INDIANA DEPARTMENT OF TRANSPORTATION

STANDARDS COMMITTEE MEETING

RE: Minutes for the February 21, 2008 Standards Committee Meeting

718-UNDR-01 Underdrain Details

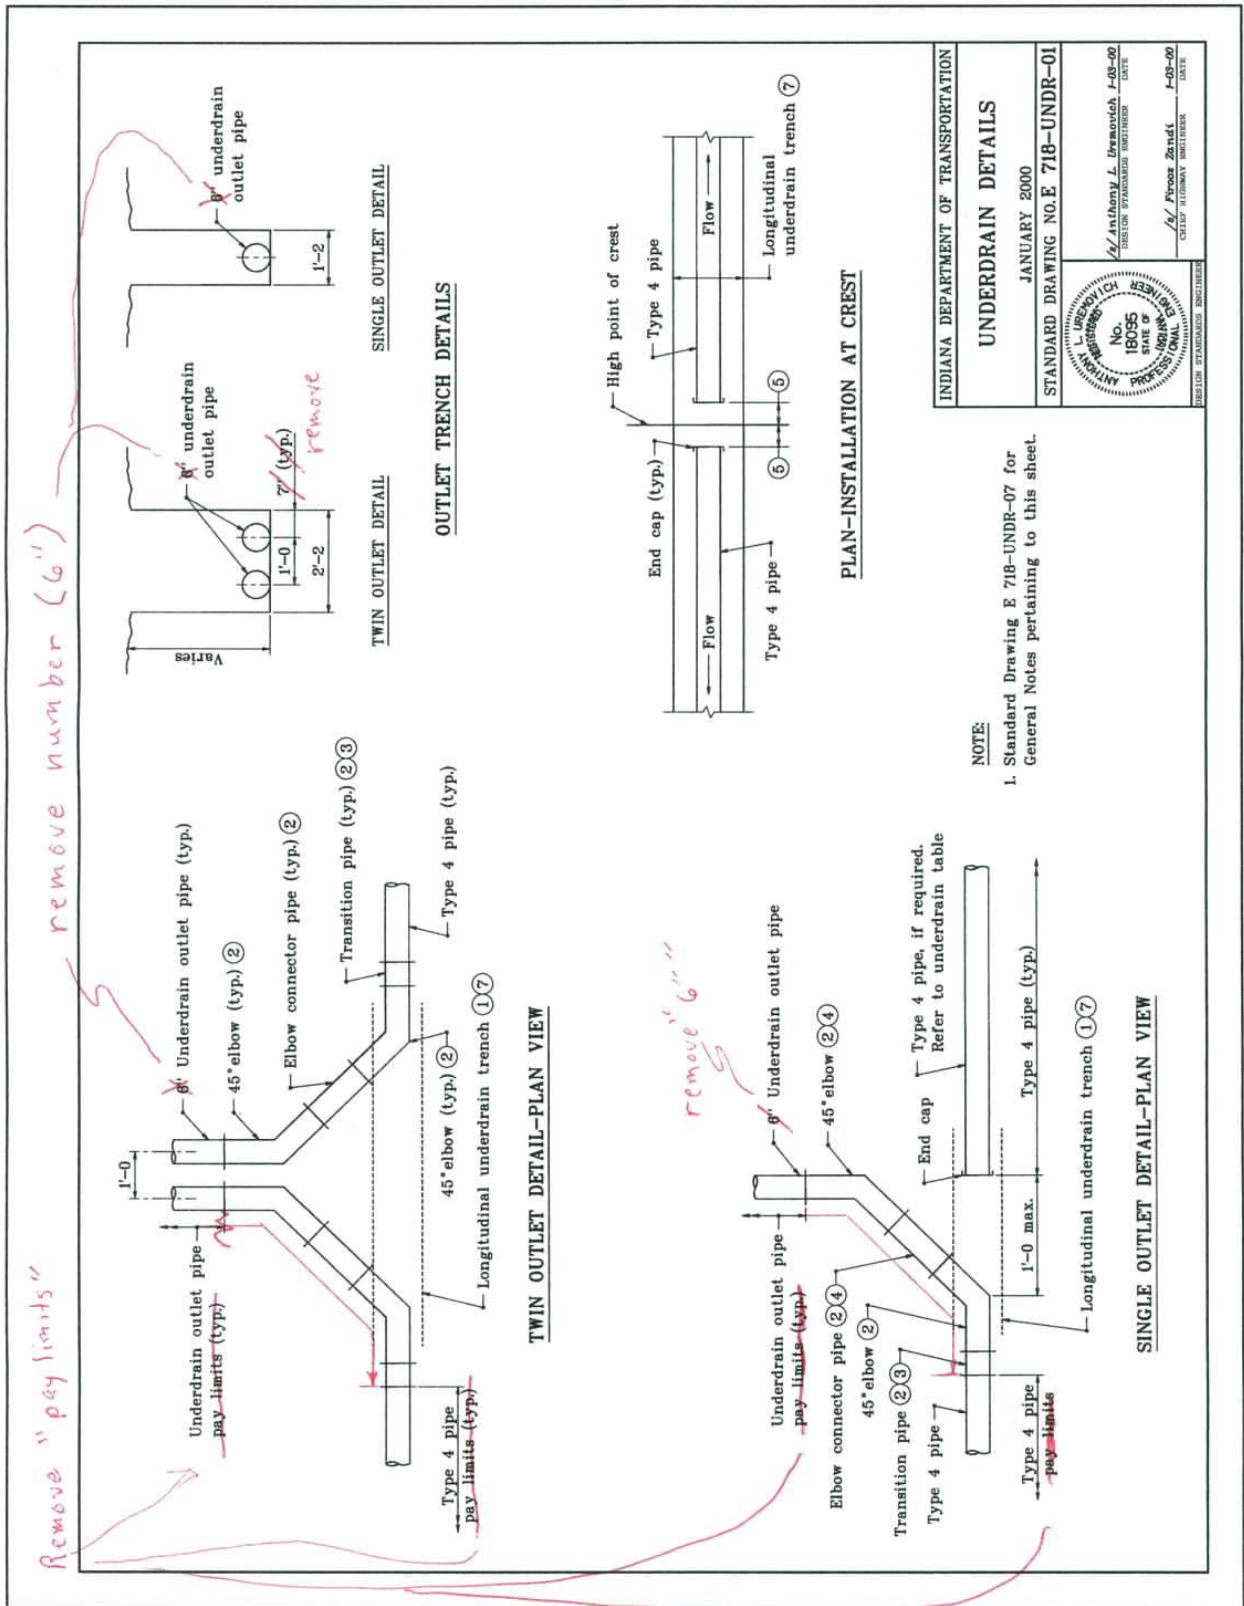
Pipe may not always be 6".

Remove references to pipe diameter.

Extend lines to show outlet pipe limits.
